project: BRUNSWICK MILL DEVELOPMENT PHASE 1

title: LEVEL 6 PROPOSED – PROPOSED DRYLINE HEAD BOXING

drawing number: L(22)226

revision: C1

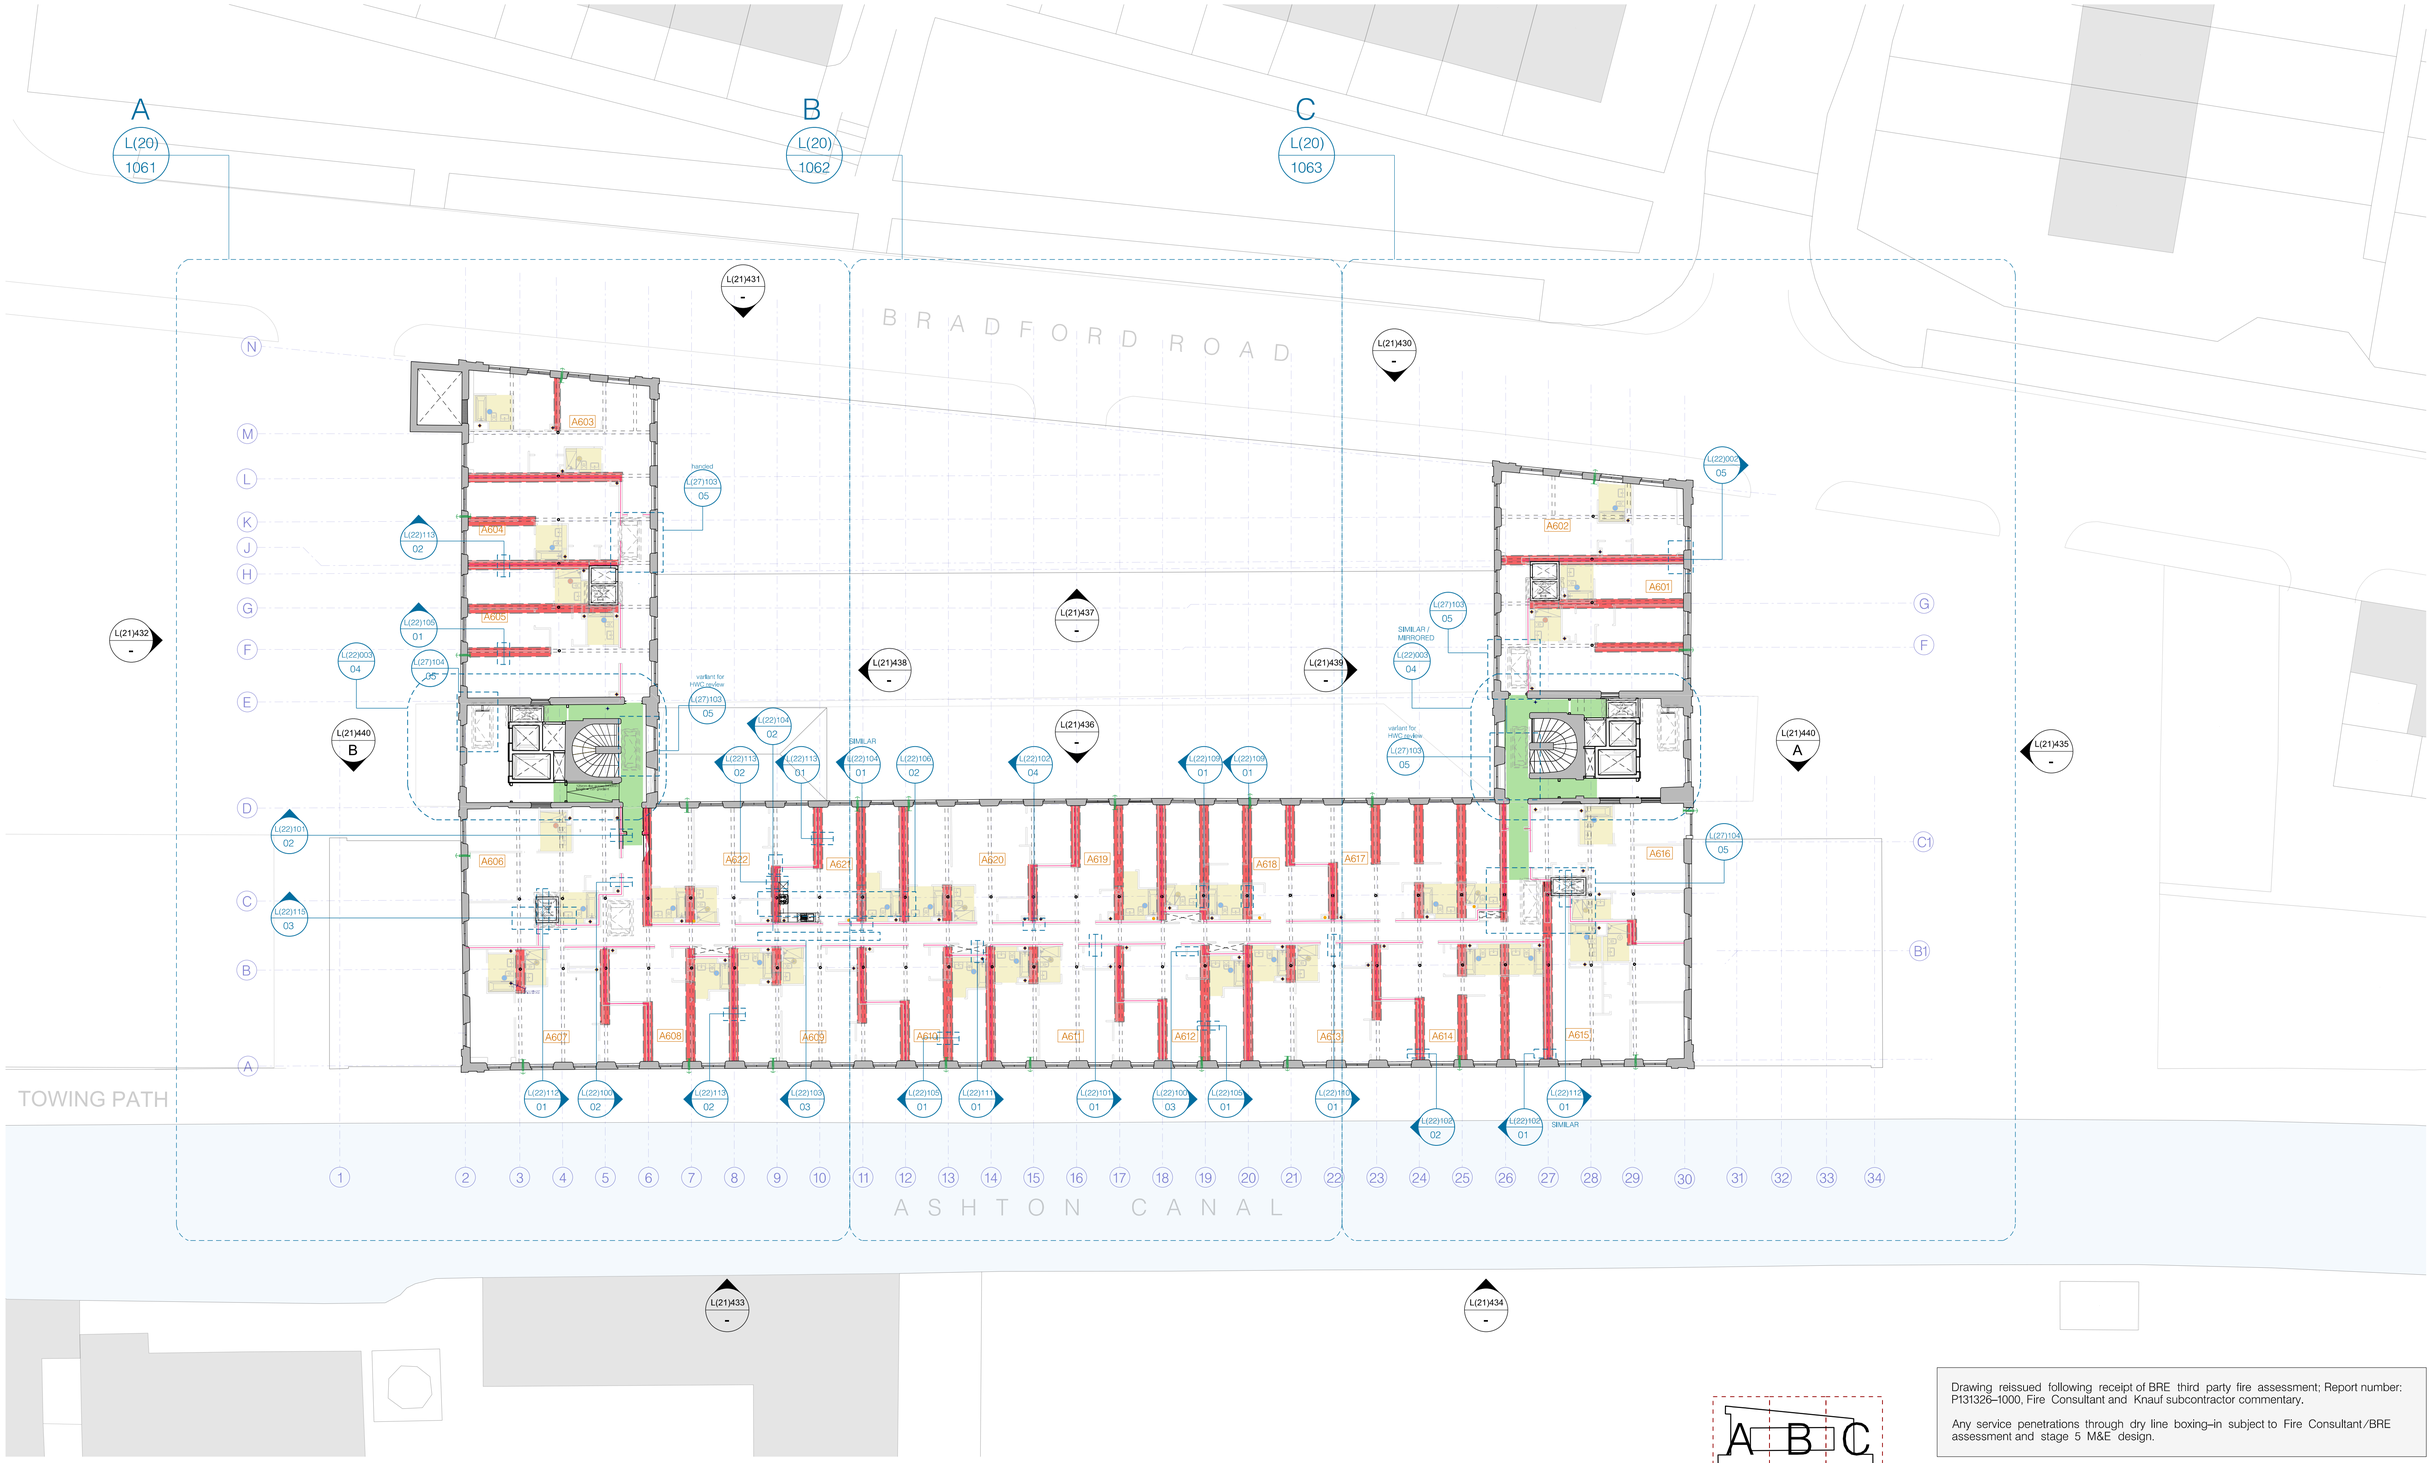
Drawing reissued following receipt of BRE third party fire assessment; Report number: P131326–1000, Fire Consultant and Knauf subcontractor commentary.

Any service penetrations through dry line boxing–in subject to Fire Consultant/BRE assessment and stage 5 M&E design.

C1 12.02.26 UPDATE TO GA PLANS. POST BRE REPORT
